Re: SSI-76014961 Muswellbrook Pumped Hydro - Changes from Scoping Report

Table 2.1 Key changes from scoping report

Figure 2.2 EIS indicative Project footprint

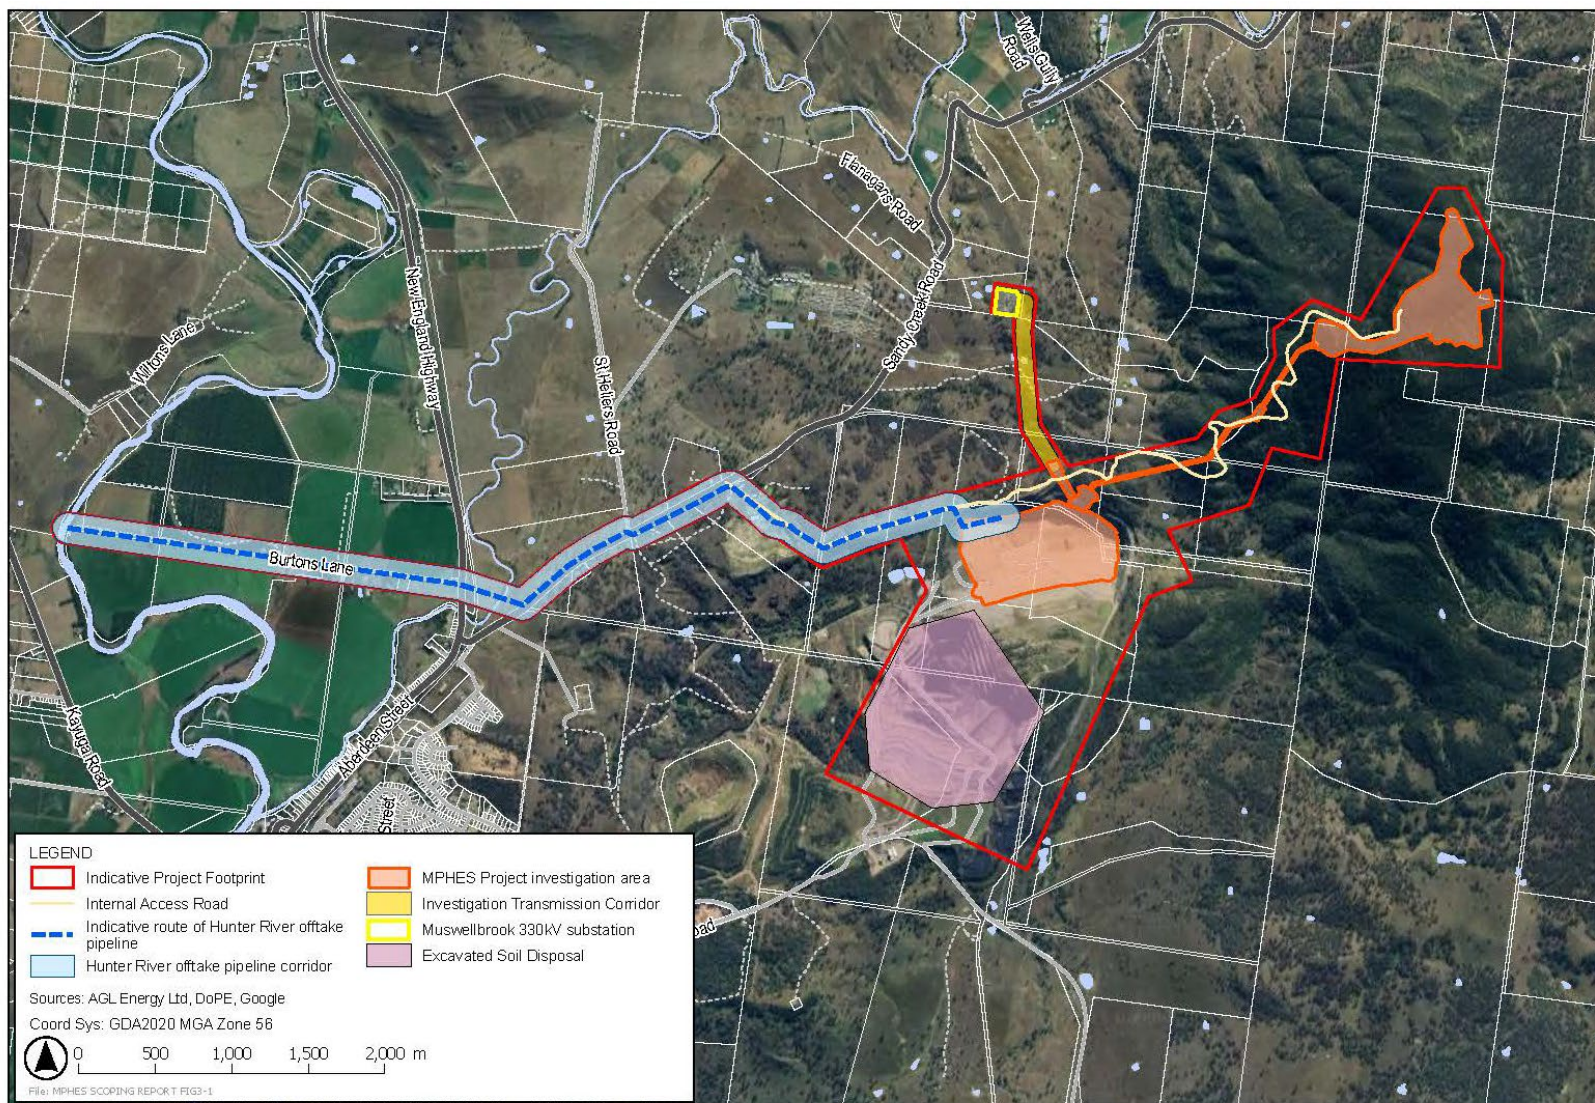
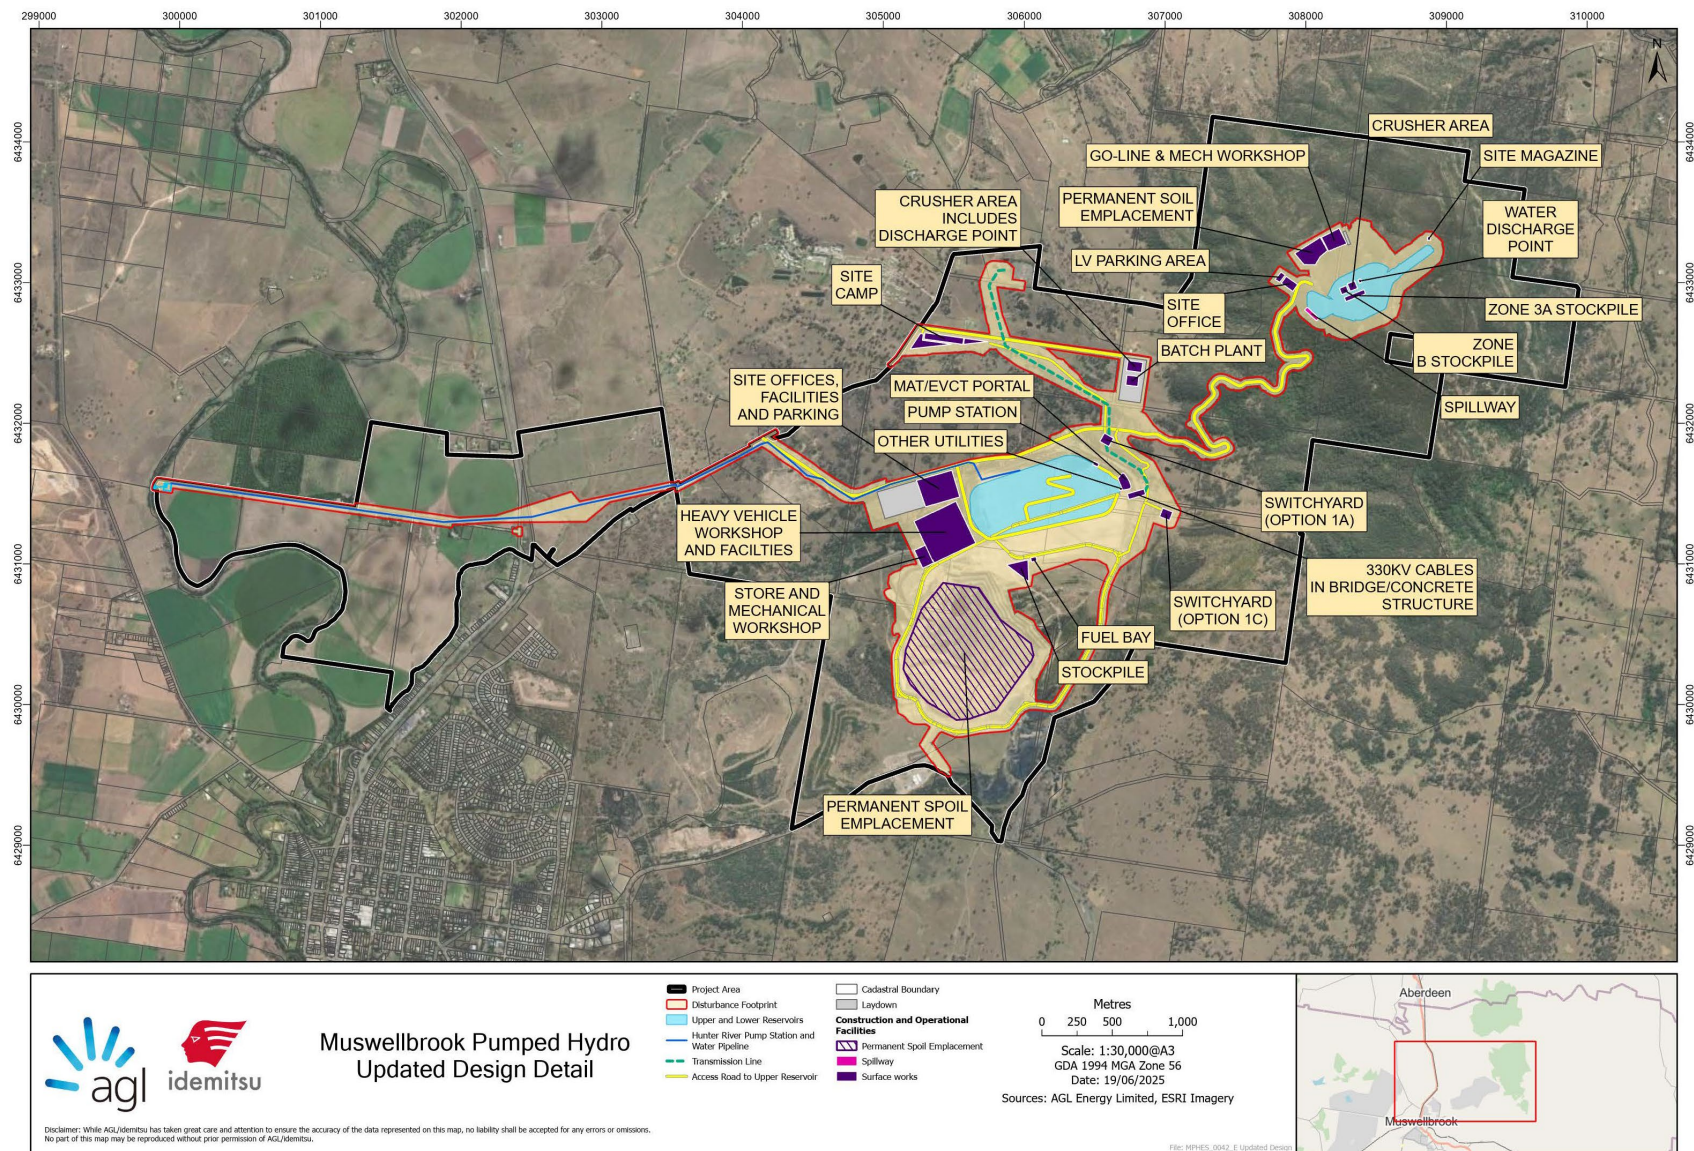
Figure 2.1 shows the indicative Project footprint as provided in the scoping report. Figure 2.2 provides the Project layout that will be assessed in the EIS.

3.1.1	Penstock location	Combination of tunnel and surface penstock	Fully underground penstock
3.1.1	Number of units	Up to four hydro-electricity generation units	Two hydro-electricity generation units

3.2.1	Reservoir elevations	Upper reservoir elevation approximately 580 m AHD Lower reservoir 130 m AHD	Upper reservoir elevation approximately 590 m AHD Lower reservoir 165 m AHD The lower reservoir has been raised to allow for hydraulic isolation from the surrounding groundwater catchment which is understood to be locally lowered and will equilibrate over the life of the project above current levels. This reduces the risk of pressure on the liner from the surrounding groundwater.
Figure 3.2 Project layout 3.2.3iii	Transmission line and connection (altered)	Transmission line is through Lot 180 DP627509 and Lot 41 DP1112699. Connection on the east of the existing substation. Land agreements for an easement will be required for the freehold properties affected by the transmission line corridor.	Transmission line is still through Lot 180 DP627509 and Lot 41 DP1112699 Slightly different alignment to enable connection on the west of the existing substation following engagement with Transgrid. Options to purchase have been secured over these properties.

Figure 3.2 Project layout	Temporary construction areas (new)	-	Inclusion of temporary construction areas on Lot 41 DP1112699
Figure 3.2 Project layout	MCC access road connection (new)	-	Footprint extended slightly to allow connection with existing mine access road to facilitate construction access via Muscle Creek Road.

Scoping section	Element	Scoping	EIS
Figure 3.2 Project layout	Accommodation camp (new)	-	Inclusion in the footprint of an accommodation camp for up to 500 workers and internal access roads linking this to the lower reservoir on Lot 180 DP627509.
Figure 3.2 Project layout	Hunter River pipeline corridor	The project layout as provided in the scoping report shows an indicative alignment for the Hunter River pipeline corridor along Burtons Lane.	The Hunter River pipeline corridor remains at Burtons Lane, with some modification of the corridor near the New England Highway and Sandy Creek Road in consultation with landowners and Transport for NSW.
Figure 3.2 Project layout	Access road to the upper reservoir	The access road to the upper reservoir on the western side of Bells Mountain is indicated on the project layout figure.	The access road to the upper reservoir on the western side of Bells Mountain has been modified with consideration of avoidance of existing transmission infrastructure, ecological impacts and inclusion of sedimentation and erosion controls.

3.3	Development footprint	Excluding Hunter River water pipeline: 566 ha	Including Hunter River water pipeline: 421 ha
Table 3.4	Construction methods	Lower reservoir and intake: Pit 2 is already excavated. The lower intake portal will likely be excavated using civil methods into the side of the reservoir while the pit is dry. Upper reservoir and intake: Likely construction will include clearing and ripping, drill and blast, and civil excavation. The intake will likely be constructed into the base of the reservoir as a short shaft. Headrace: Likely construction will include drilling, boring and blasting methods, and civil construction works. Power station: Likely construction will include drilling, boring and blasting methods, and civil construction works. Ancillary facilities: Civil and building work for the construction compounds, lay down yards, concrete batching plant, and site offices.	Amended construction methods: - Geotechnical information has indicated less blasting is required for underground works and mechanical excavation will be preferentially used for the power station and headrace New and additional construction methods include: - Waterway tunnels would be constructed with mechanical excavation (e.g. road headers). - Hunter River water pipeline will be under-bored under the New England Highway and the rail line.
